Submission of Further Information (FI)

Proposed Temporary Shop and Services (Retail Shop for Hardware Groceries and Construction Materials) with Ancillary Facilities and Associated Filling of Land for a Period of 3 Years in "Agriculture" Zone, Various Lots in D.D. 119, Yuen Long (Application No. A/YL-TT/767)

Further Information for Planning Application No. A/YL-TT/767

Response-to-Comments

| February 2026 | Lots 1677 RP, 1678(part), 1679(part) and 1692 in D.D. 119 | Plan 3a (P 25086) |

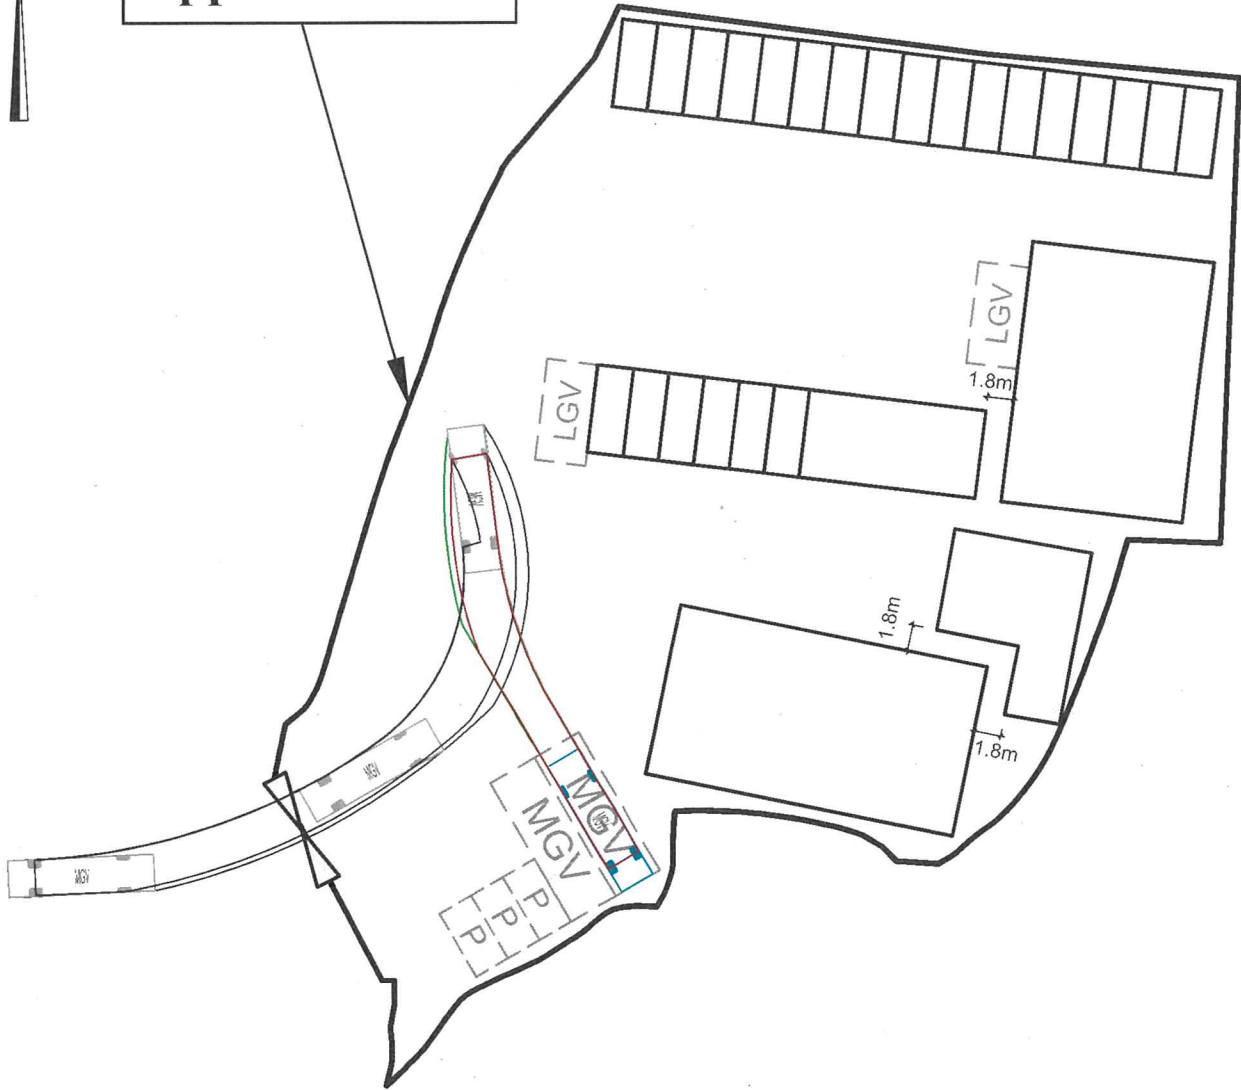
| II. | Comments | Responses |
|------------|---|--|
| 1. | <p>We have written to PlanD on 8 September 2005 regarding the revised "Code of Practice on Handling the Environmental Aspects of Temporary Uses and Open Storage Sites" (the COP). Since the proposed use will involve heavy vehicles and there are residential buildings located within 100m of the subject site boundary, environmental nuisance is expected according to the COP. As such, we do not support the captioned application according to the COP.</p> | <p>Medium goods vehicles instead of heavy goods vehicles will be adopted for the daily operation of the Proposed Development. Please refer to the revised Layout Plan (Plan 3a) for details.</p> |
